RECALL 23V262 / 2023-217 REMEDY INSTRUCTIONS

WAY SOLAR PANEL FIELD REWORK INSTRUCTIONS

Recall Number:	23E-027		
Product:	WAY Solar Panel		
Date:	April 13, 2023	Labor Rate:	0.7 Hours

This document provides rework instructions for WAY solar panel mounting brackets. The corrective action for Recall 23E-027 includes installing additional brackets and hardware; the solar panel does NOT need to be removed from the unit.

For Type A Mounting Bracket

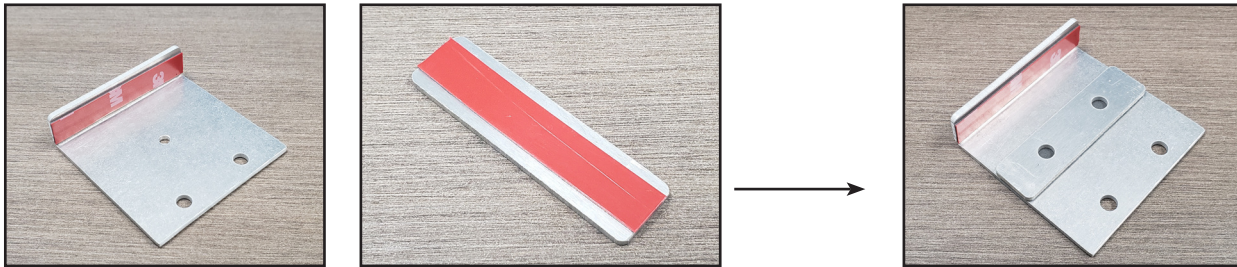
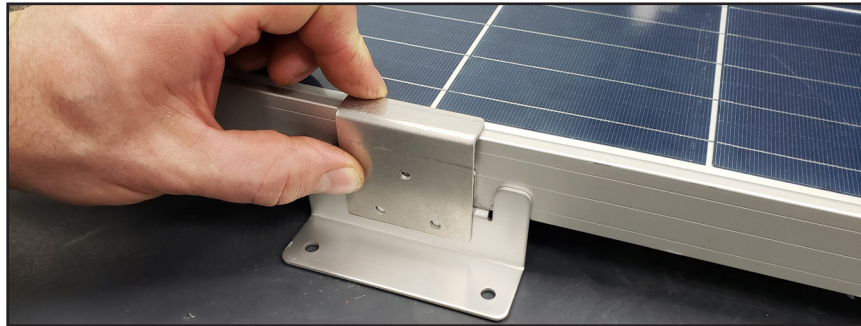
1. Peel the adhesive backing on the small rectangular spacer piece and stick it to the add-on L-bracket centering it on the single mounting hole at the center of the bracket shown below.

2. Peel the adhesive backing on the L-bracket and attach it to the panel, centering the add-on bracket to the pre-existing mounting bracket as shown below. Make sure the bracket is flush to the top and sides of the panel.

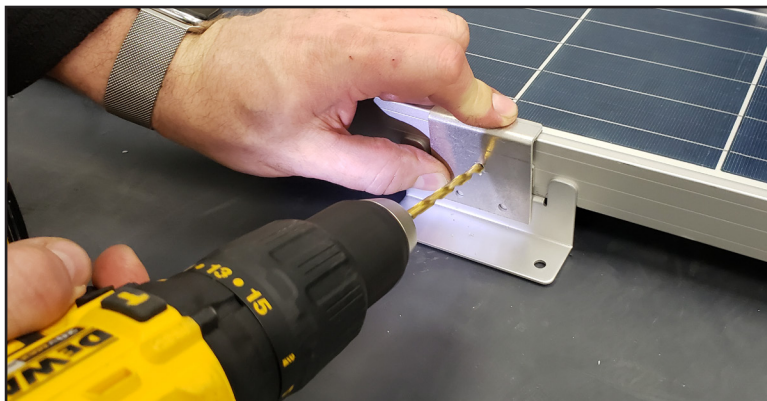
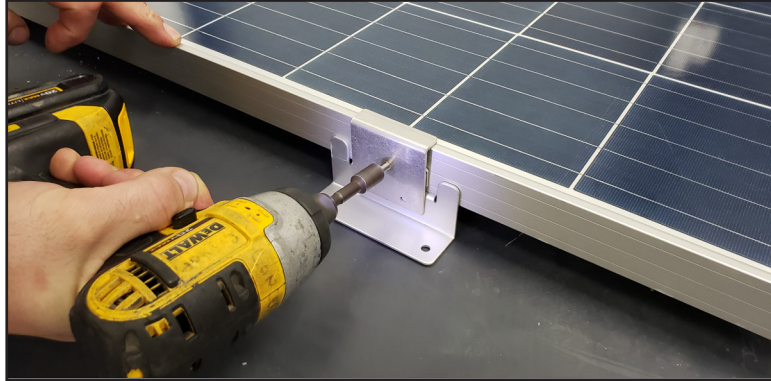
3. Drill a hole (using the 3/16 size drill bit from the kit) through the L-bracket pilot hole and the solar panel. Drill into the panel as straight as possible. Drilling at an inclined angle could result in hitting the M6 fastener of the pre-existing bracket behind the panel frame.

4. Use the impact driver tool with the recommended socket and drive one of the #12 thread-cutting screws into the above drilled hole and secure the add-on bracket to the panel.

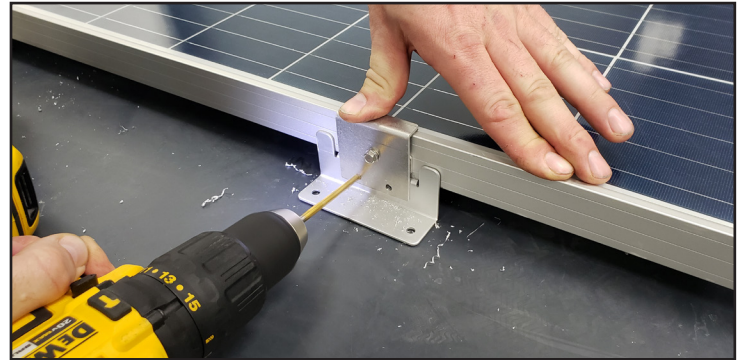
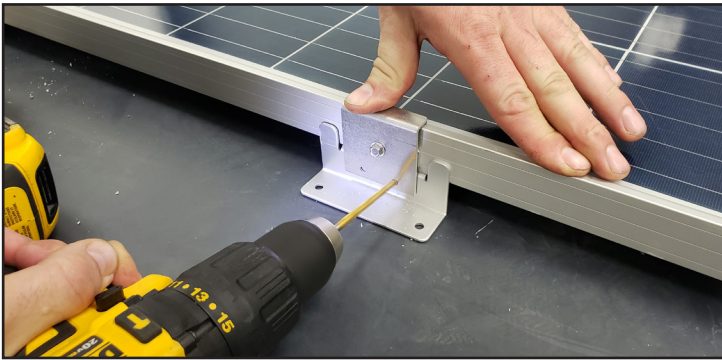
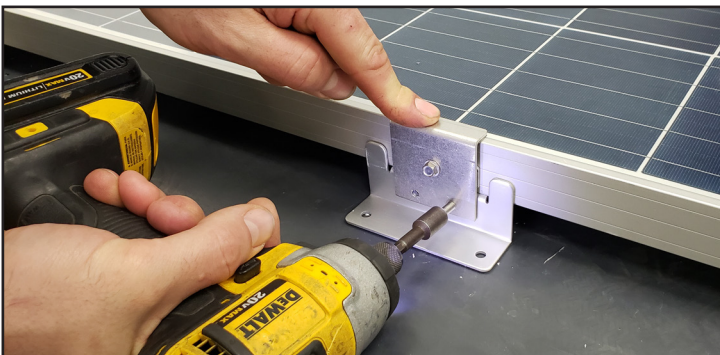
5. Drill out the other two holes on the add-on bracket and through the pre-existing mounting bracket.

6. Drive the other two #12 screws into the recently-drilled holes and secure the add-on bracket to the pre-existing bracket.

Case 1: Flush mount

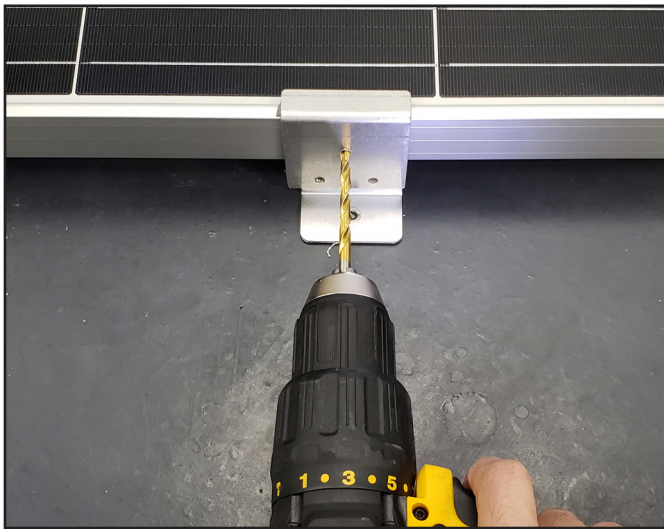
1. If the bracket front face is flush to the panel, then no spacer is required. Peel the adhesive on the L-bracket and stick it flush to the panel, centering on the pre-existing bracket.
2. Drill the top hole of the bracket through the panel and install a #12 screw.

3. Follow the same process for drilling the other holes and secure the bracket with the other two screws.

Case 2: Bracket recessed

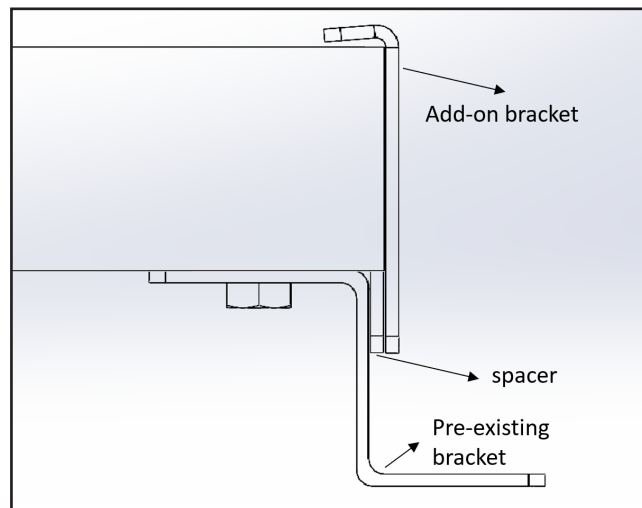
1. If the bracket front face is recessed, the add-on bracket won't align flush to the panel and creates a gap between the add-on bracket and the pre-existing bracket at the bottom.
2. To fill the gap, stick the spacer piece using adhesive tape on the pre-existing bracket.

Case 3: Bracket protruding out

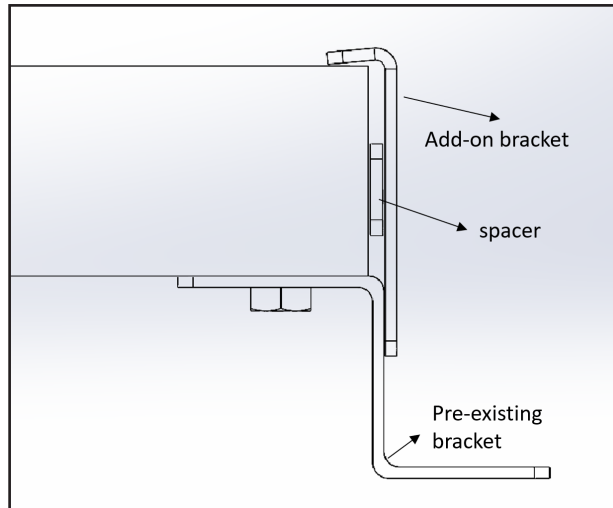
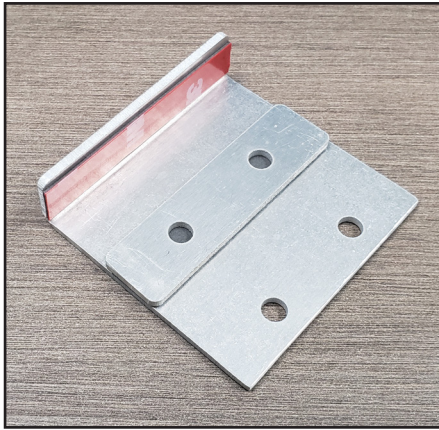
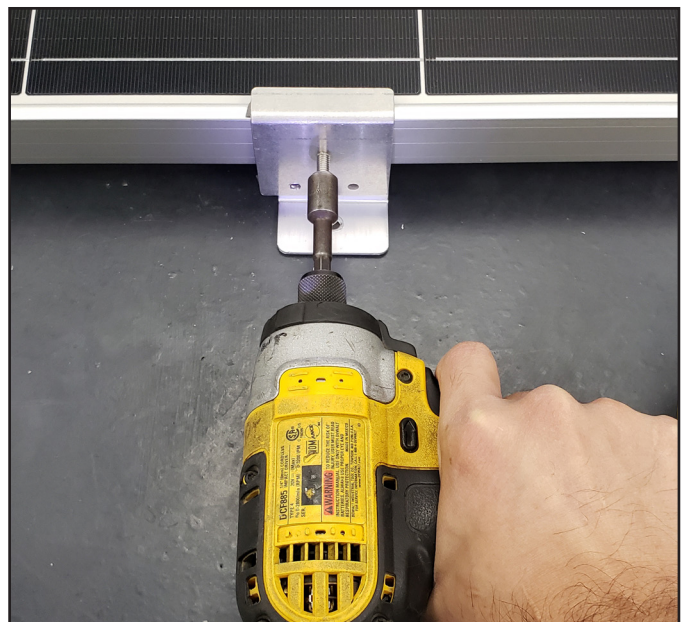
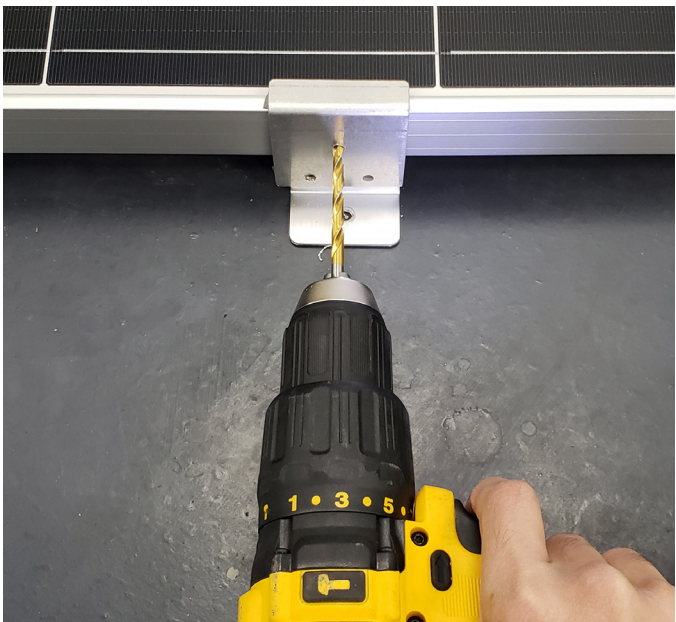
1. If the bracket's front face is protruding out, the add-on bracket won't align flush to the panel and creates a gap between the add-on bracket and the panel.
2. To fill the gap, stick the spacer piece on the bracket as shown below. Try to center the spacer on the top hole as much as possible.

3. After installing the spacer piece in the corresponding location, peel the adhesive backing on the add-on bracket and stick it flush to the panel.
4. Drill the top hole first and thread a screw into the panel.

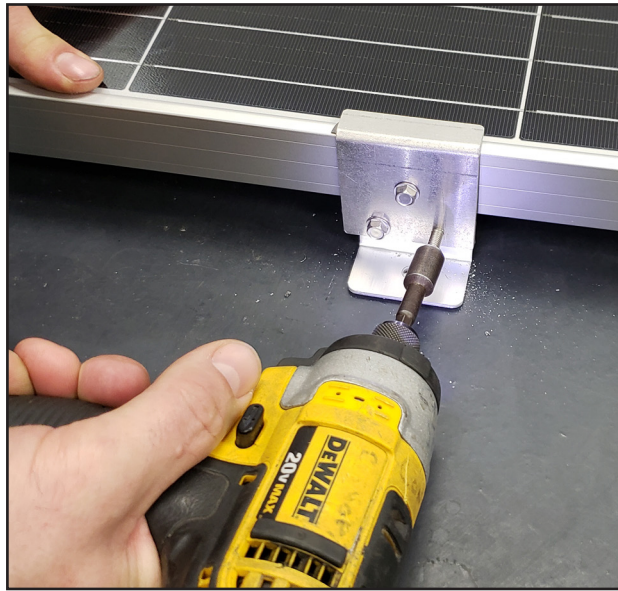
5. Drill the other two holes and secure the bracket with the two more #12 screws.
